List of changes from consented scheme:

Client Sign Off	Architect/Originator: Tate Harmer	Unit G182, Stamford Works, 3 Gilbert Street, London N16 8JH Tel: +44 (0)207 241 7481 Email: studio@tateharmer.com	Do not scale. All dimensions to be checked on site. This drawing is copyright.
	Client: Platinum Land		Date of Origin: 28.11.17
	Project: Belsize Park Firestation		Drawn By: ABF
	Drawing Title: Proposed Roof Plan		Scale: 1:100 @ A1
Drawing Number: BFS THA PR PA 140 P3		Revision: Planning

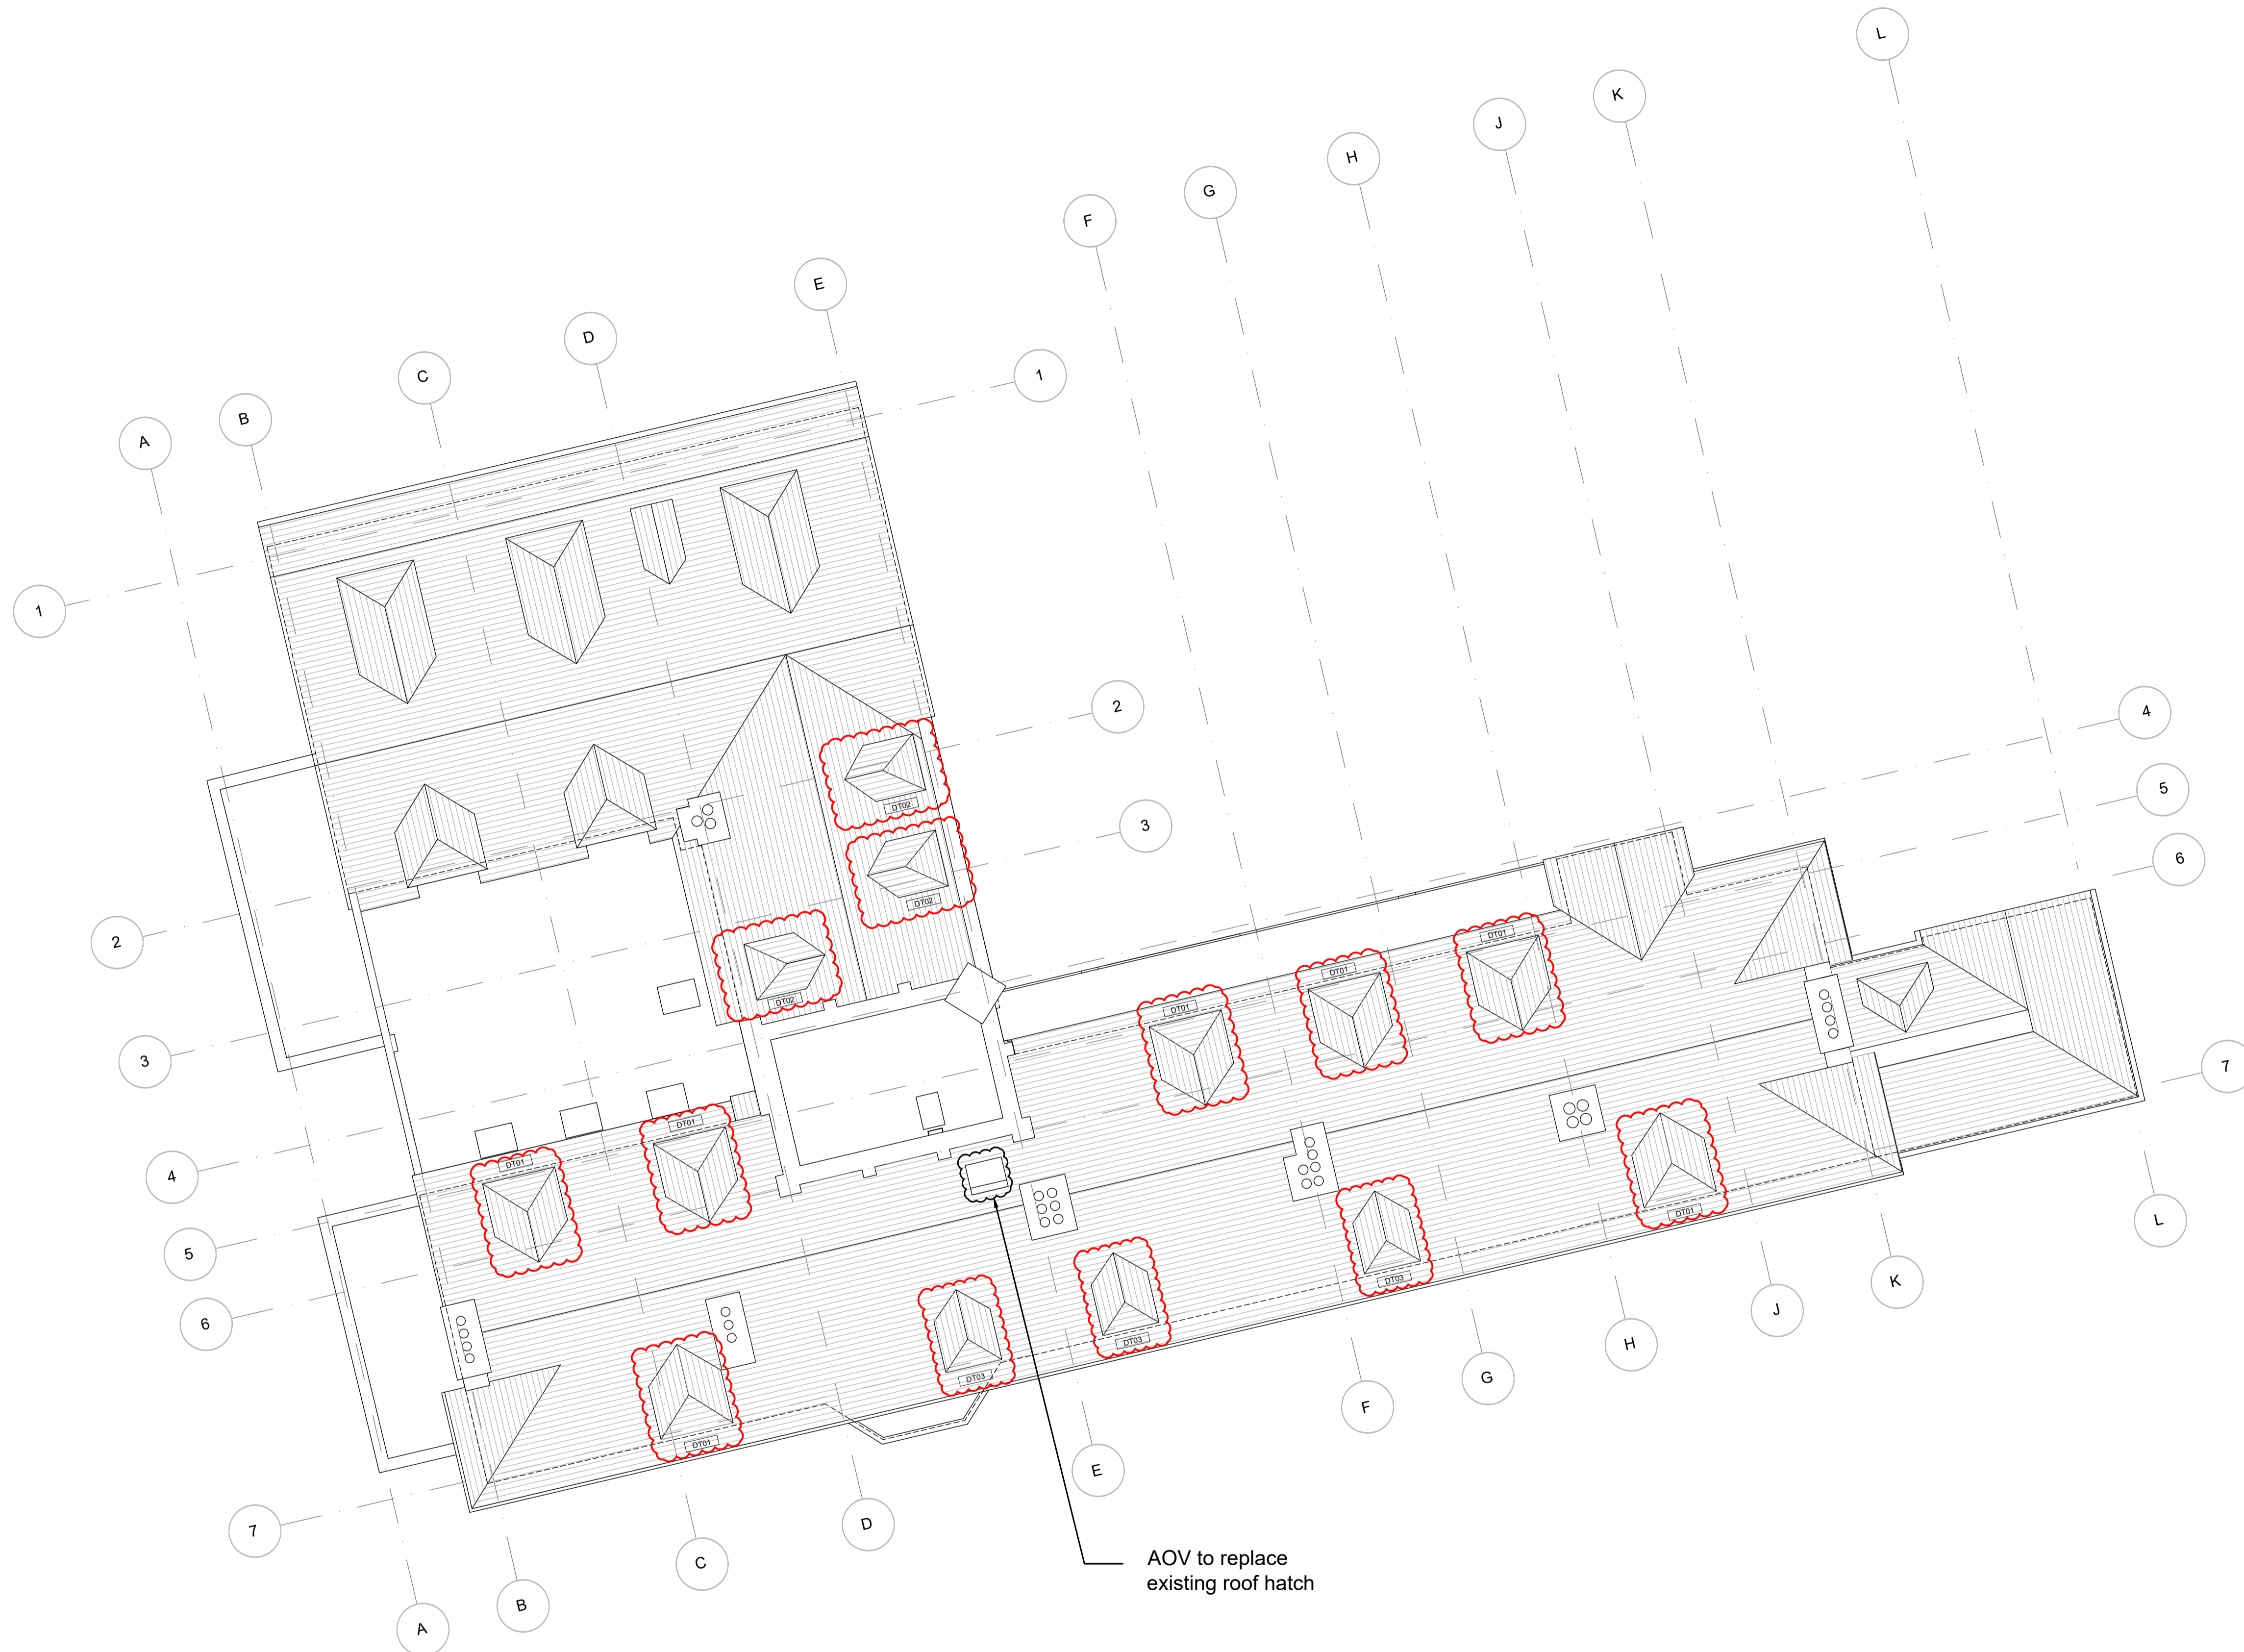
- AOV to replace existing roof access hatch.
- Dormer cheeks made to match dimensions as per existing dormer windows in courtyard.

AOV to replace existing roof hatch
